Re: Assessment of status of Farmers Conservation Alliance (FCA) Horizontal Screens as an Experimental Fish passage Technology

ENCLOSURE 3

Subject: August 13, 2009, Widow's Creek Site Inspection

Image 1, organisms found on the screen

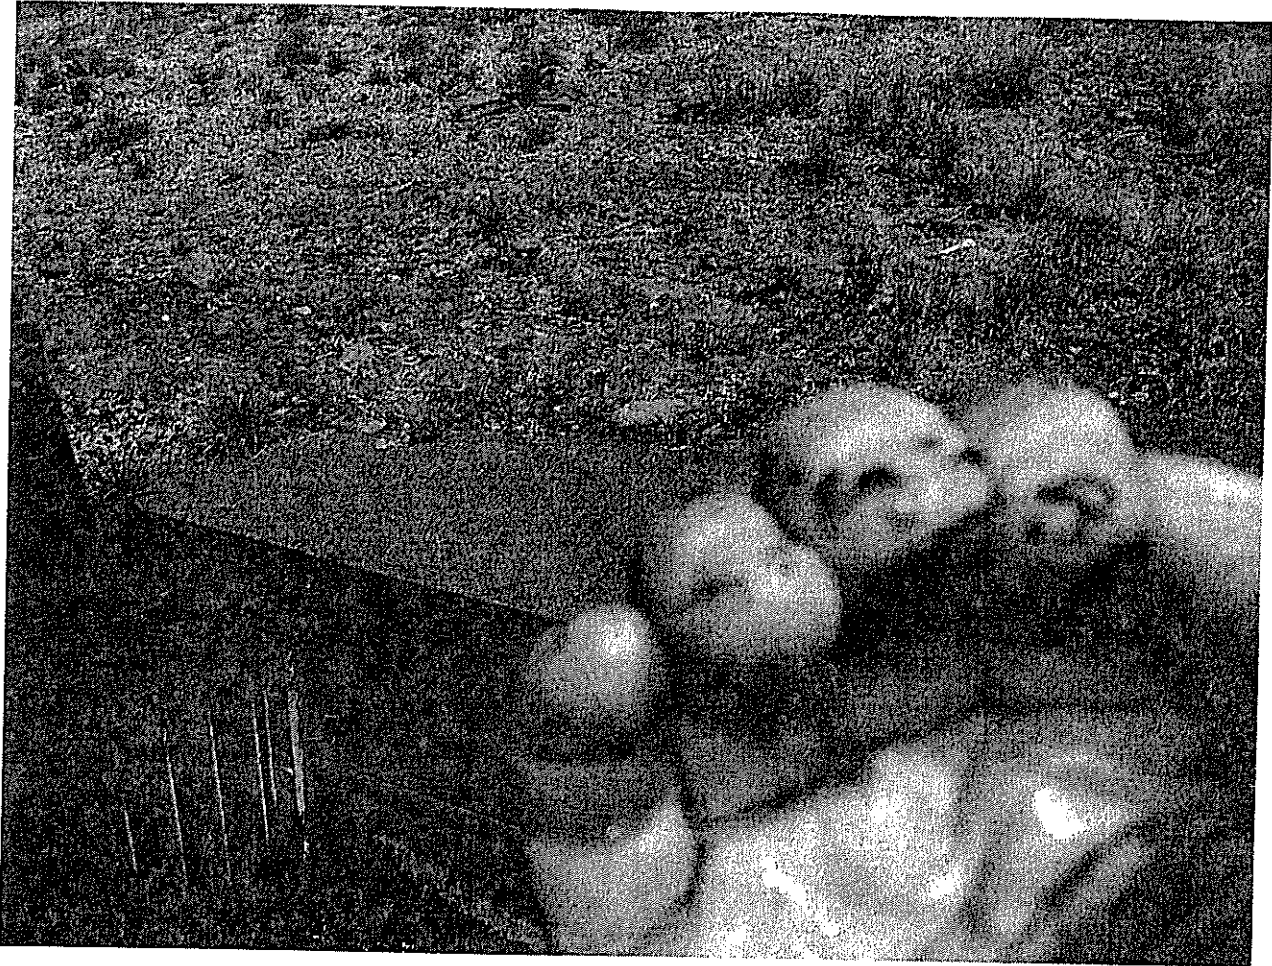
Typical of most northwest stream and river systems, inflow from Widow's Creek conveys a significant sediment and debris load. During this visit I noted that each of the three screens had some degree of debris occlusion comprised of a mixture of inorganic and organic debris (Caddis Fly, organisms that may have been Western Brook Lamprey ammocoetes or aquatic insects, small gravels, algae, and various forms of other organic materials, see Image 1). Regular fouling occurs and is documented as significant at times (see Image 2). ODFW and the ranch manager stated that the screens require cleaning at least one time per day.

Image 4, upstream screen operating water depth

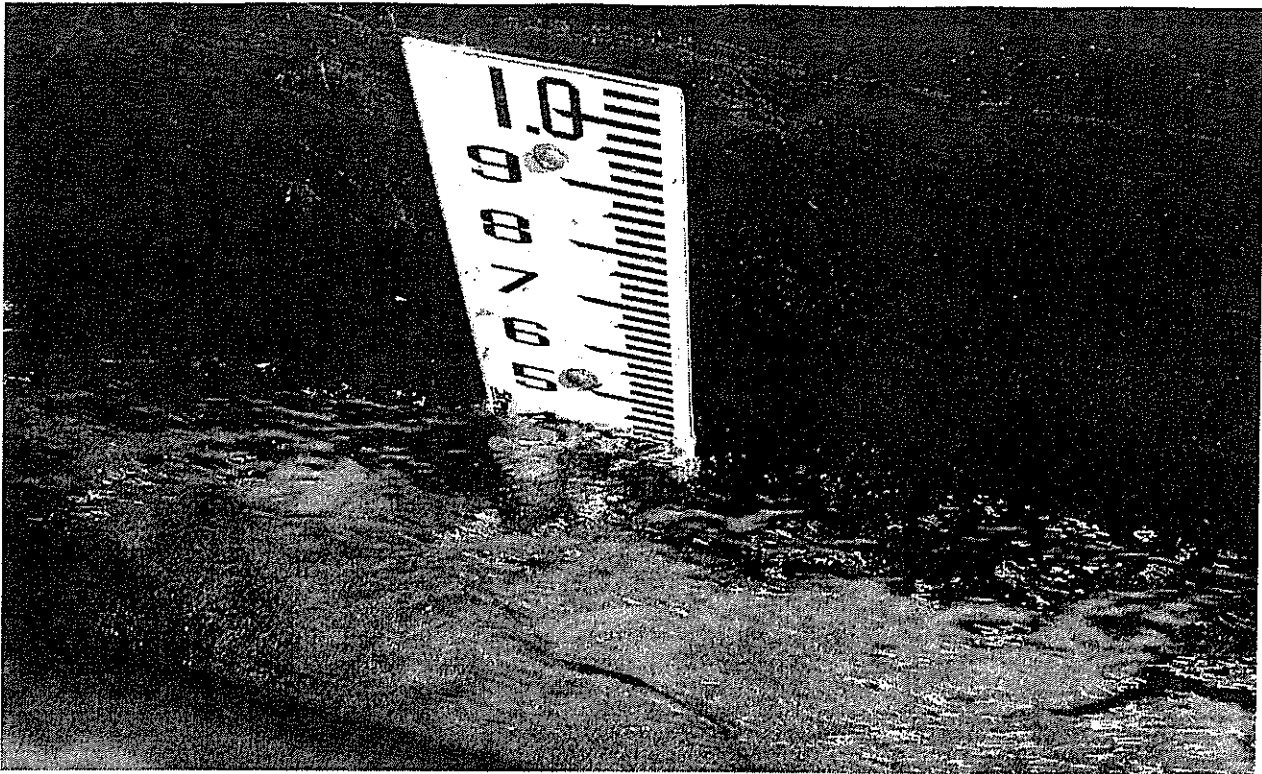
I observed the upstream screen and the middle screen operating below the “design” condition of 6 inches (the design parameter stated to us by FCA prior to installation of the Widow’s Creek project). In Images 4, 5, and 6, below, Image 4 represents the upstream screen and documents the operating depth of 0.4 foot (4.8 inches), Image 5 represents the middle screen and documents the operating depth of 0.4 foot (4.8 inches) and Image 6 represents the downstream screen and documents the operating depth of 0.55 foot (6.6 inches). ODFW stated that the downstream screen was operating in an abnormal way and when I observed the screen, I noted that a large amount of return flow was conveyed in the diverted water bay, which caused the screen to backwater (Image 7). Therefore, my observation of the water depth over this screen was that it exceeded the 0.5 foot of water depth planned for by the designer, but that it likely did not represent normal operating conditions.

Image 6, downstream screen operating water depth

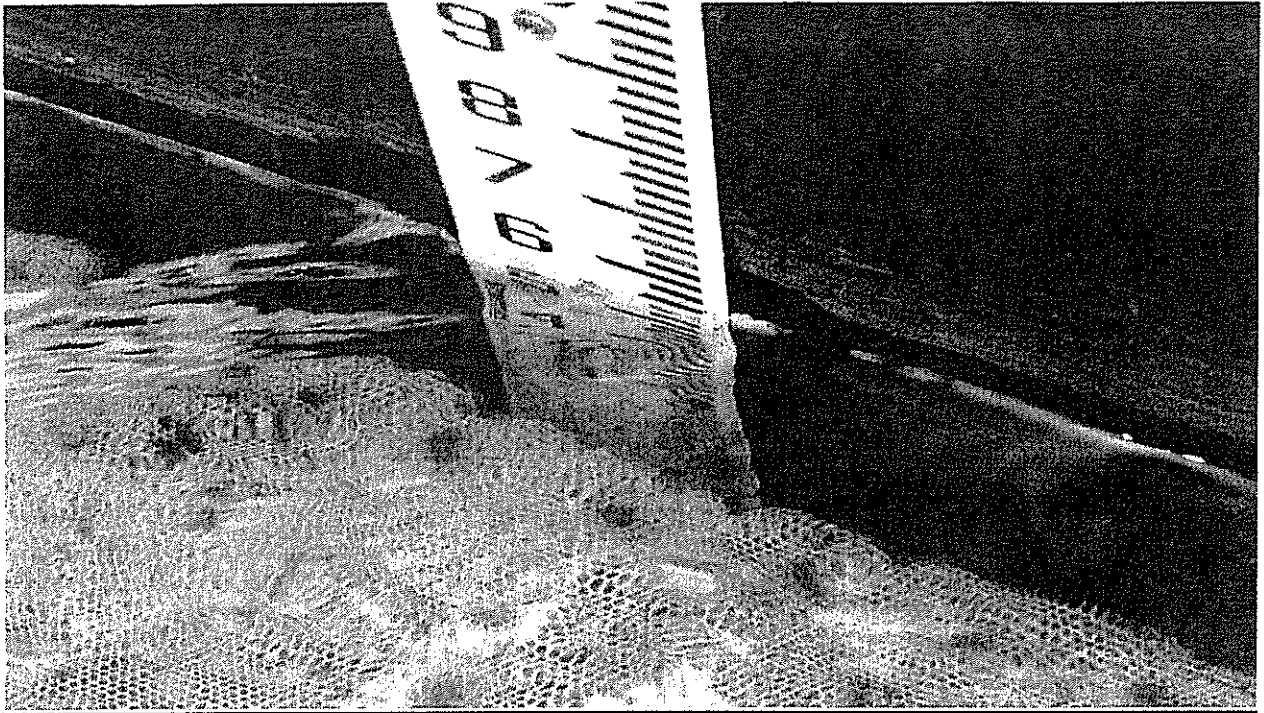
During our tour of the downstream screen, I observed fish on the screen, maintaining location, which may indicate delay on top of the screen. In fact, my shadow caused these fish to move up and down the screen. The water surface was maintained between 0.4 feet (4.8 inches) and 0.55 feet (6.6 inches) (varying between the different screens, with the upstream screen operating at 0.4 foot (4.8 inches) and the middle screen at 0.4 foot (4.8 inches) and the lowest screen at 0.55 foot (6.6 inches), with the lowest screen operating in an unusual mode, see the discussion below). This illustrated an opportunity for fish to hold up on the screen. The fish were readily visible to and could be spotted by a predator.

Image 8, upstream passage barrier

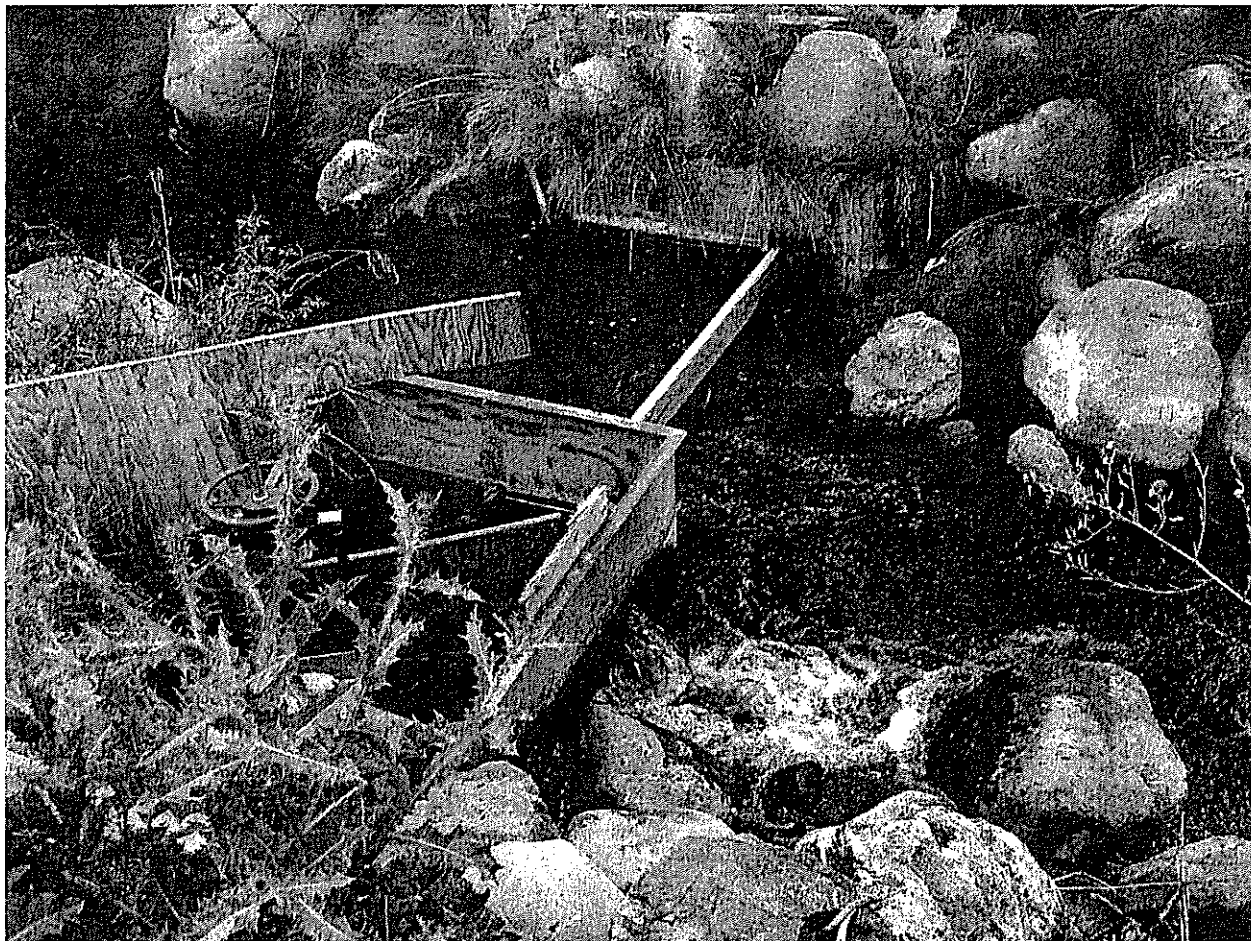
Two issues related to the bypass operation were reported by ODFW. Late in the operating season, no flow in excess of the diverted flow will be available for bypass, meaning that the bypass will be closed. This is a concern and violates the criteria the special FCA screen criteria. Also, I observed that even with flow available for bypass, fish are routed directly below the screens. I observed fish below the diversion structures. The three diversions provide a complete passage barrier to any fish interested in passing upstream (image 8).
